# UNITED STATES PATENT AND TRADEMARK OFFICE

APPLICATION NO.	FILING DATE	FIRST NAMED INVENTOR	ATTORNEY DOCKET NO.	CONFIRMATION NO.
09/759,579	01/12/2001	Robert F. Heard	91805001	1809

# Office Action Summary

FIG. 7

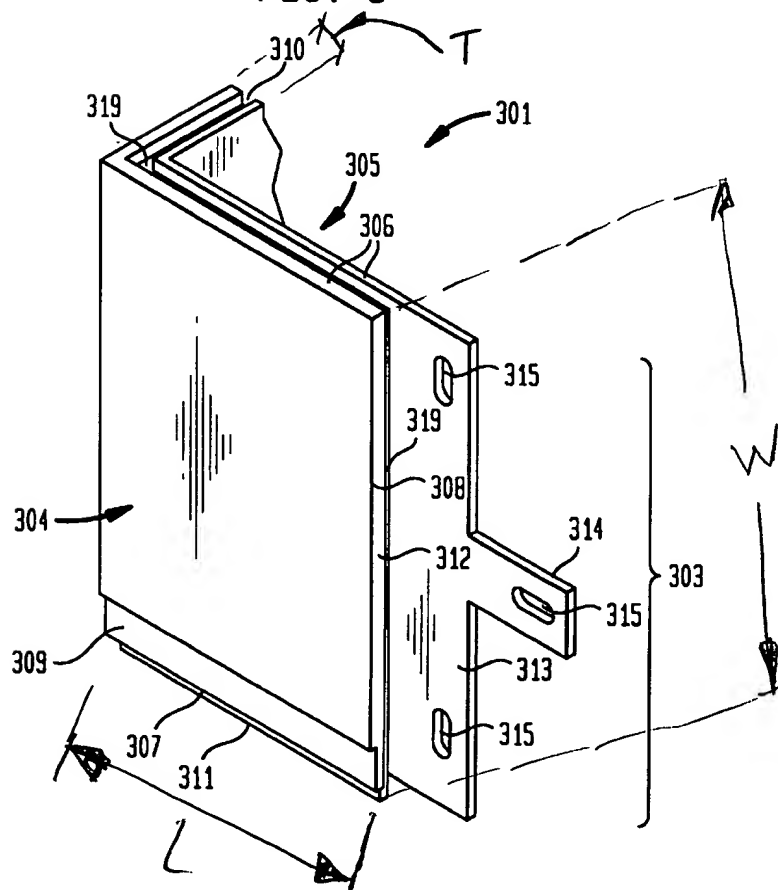
Claims 1,2,4,5,7-11 and 20 are rejected under 35 U.S.C. 103(a) as being unpatentable over US Patent #5,836,123 to GULINO. Regarding claims 1 and 20, GULINO discloses the use of a decorative member (701,801) including a solid rectangular portion not shown but similar to rectangular wing portions (303) each having a length (L) that is greater than a width (W) thereof, and a thickness (T). The rectangular portion further includes a top surface (704,804) and a bottom surface (705,805) wherein the

bottom surface (705,805) overlies the building as shown in figure 1. The decorative member of GULINO also includes a flange portion (713,714) and (818) in parallel relationship with the bottom surface (705,805); wherein the flange (713,714) and (818) extend beyond the width (W) of the rectangular portion. GULINO also discloses the use of a channel (710,810) formed between the flange portion (713,714) and (818) and the top surface (704,804) wherein the channel is adapted to receive a siding member (S), see the marked attachment. GULINO discloses the basic claimed decorative member except for explicitly detailing that his member is a "brickmold" and except for detailing the sidings of two differing thickness may be accommodated by the channel. Although GULINO does not explicitly detail his decorative member as being a "brickmold", he does detail that his decorative member is a corner trim piece. Corner trim pieces, trim pieces, and brickmolds are art recognized equivalents for their use in providing external decorative devices to a structure. Further, the applicant is reminded that the manner in which a device is employed does not differentiate the claimed device from a prior art apparatus satisfying the same structural limitations. Hence, although the device of GULINO is a corner trim device, it is a trim device that satisfies all of the structural limitations of the claimed apparatus. In regards to the siding thicknesses, due to the step portion (colored red in the marked attachment of figure 8), it would have been obvious to one having ordinary skill in the art at the time the invention was made that the channel (710,810) is fully capable of being adapted to receive a siding have differing thicknesses. In reference to claim 2, the decorative device of GULINO includes a

decorative portion that is carried by the top surface, column 4, lines 21-26 and column 7, lines 53-61. Regarding claim 4, the flange (713,14) and (818) is integral with the decorative device. In reference to claims 5 and 7, the flange (713,714) and (818) is affixed to the building by a fastening means such as a nail, column 8, lines 24-27. Regarding claim 8, although GULINO does not detail the use of a screw per se', he does detail the use of a nail. Nail and screws are art recognized equivalents. The only requirement that GULINO has is that the fastening means not be cleated. Screws, being similar to nails are not cleated. Hence, it would have been obvious to one having ordinary skill in the art that the selection of either the nail or screw would have been well within the general skill of a worker in the art. In reference to claim 9, GULINO does not detail the use of adhesive as a type of fastening means; however, nails, screws, glue and adhesives are also art recognized equivalents for their use in the art as securing means. Again, the selection of either would have been an obvious matter of design choice. Nail or screws might be employed if the type of decorative member is made from a material that does not secure well with an adhesive; whereas an adhesive might be employed alone or in addition to a nail or a screw. When an adhesive is used along with nails or screws, usually, the adhesive is used to provide added protection in securing the members. Regarding claim 10, the flange (713,714) and (818) also includes holes (715,815) for receipt of the fasteners. In reference to claim 11, the decorative device of GULINO is made from a polyvinyl chloride. GULINO does not explicitly detail whether his PVC is cellular; however, PVC is commonly available in the

art in a cellular form and a resinous form. The selection of either would have been an obvious matter of design choice. Both cellular and resinous PVC plastics have similar properties or characteristics and function similarly. Hence, the selection of either would have been well within the general skill of a worker in the art. In further regards to claim 20, GULINO also discloses the use of a step portion, colored red in the marked attachment.
